S U B M I S S I O N : P L A N K  
a written submission by way of further objection to DA 2020/0096

Re:  
26 Ralston Road, Palm Beach, NSW 2108  
DA 2020/0096  
Amended Plans

WRITTEN SUBMISSION: LETTER OF OBJECTION  
Submission: Plank

Tenacity Viewing Corridor from 8 Ebor Road Palm Beach

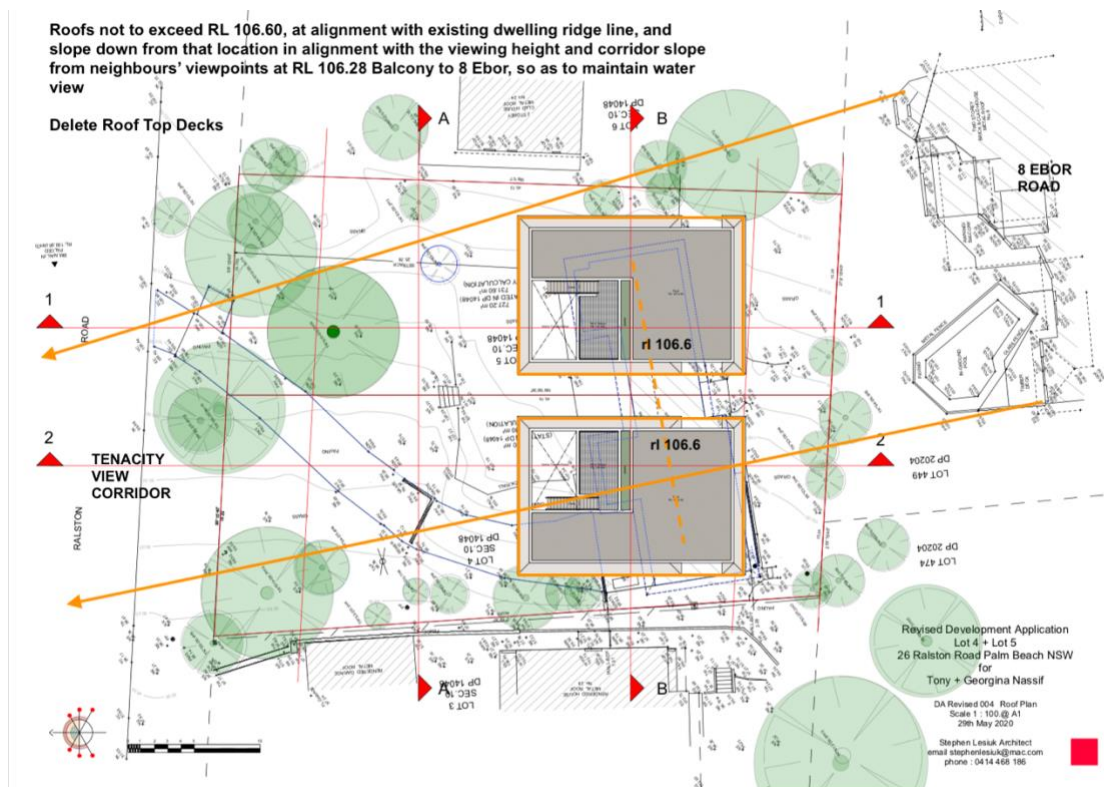
The view from my windows and deck towards the water view, and the land-water interface will be lost.

The existing view is a 'moving landscape', rather than just a 'scenic outlook', given the activity on the water.

The extent of view loss is severe to devastating, and the features lost are considered to be valued as identified in Step 1 of *Tenacity*.

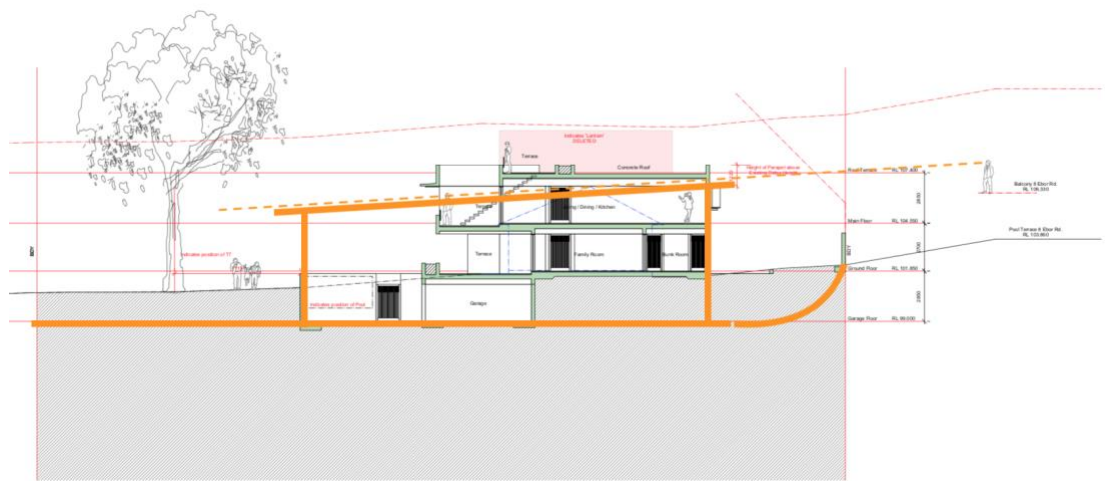
The applicant should have informed the design by a complete view loss consideration that would have clearly identified that any development over the existing ridge level would be problematic. There may be architectural solutions that maintain my view, by proposing development above the existing ridge line in some part of the large site, but this needs careful consideration by the Applicant, along with templates to fully test the design outcome.

As stated earlier in this Submission, the Applicant has the opportunity to resolve this issue by raising the proposed ground floor of both dwellings to RL 100, with 3m storey heights, allows for a roof at the north edge of both dwellings to be at RL 106.

A low-pitched skillion roof sloping down to the north at 1:50 falls, would adequately allow for a two-storey dwelling, with garaging at RL 100.

The roof level would be similar to the existing ridge at RL 106.6 as it passes through the alignment of the existing ridge of the existing dwelling.

The existing crossover levels are at RL 100.4, with the existing accessway crossing the RL 100 contour within the front setback zone, allowing a level access to garaging at RL 100.

Two dwellings at two-storey can be designed on the subject site, to maintain the water views from my property off a RL 100 base.
